SERVICE TECHNICAL INFORMATION

ONE POINT REPAIR

REF. NO. : SI-97-019
CUSTOMER RELATION SERVICE DIV.

MODELS : Z-M2800/M2900/VM280/VM290, NSX-F9/V800/V900
SUBJECT : No power/Sound Distortion due to power IC defect.
CONTENTS : Due to power IC(STK-419-***defect, it is caused to no power or sound distortion. It requires to modify following contents to all repair items when replace in the above mentioend power IC.

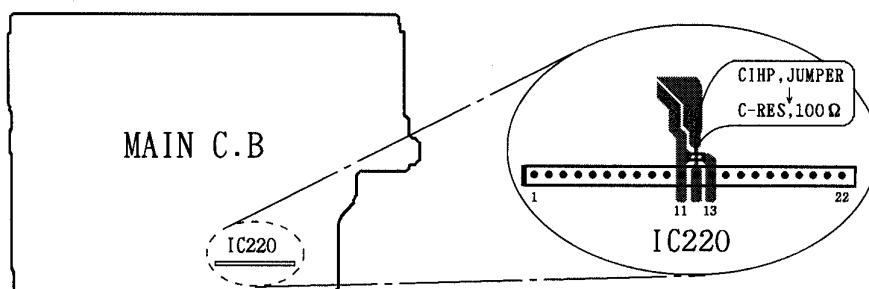
MEMO : This modification is required to do all in the above mentioned models for repair even power IC is not damaged.

REMEDY : To replace parts from chip jumper to chip resistor, 100Ω•1/8W, between pin⑪ and ⑬ of IC220.

Ref.	PARTS CODE	PARTS NAME
	88-128-101-010	C-RES, 100Ω 1/8W
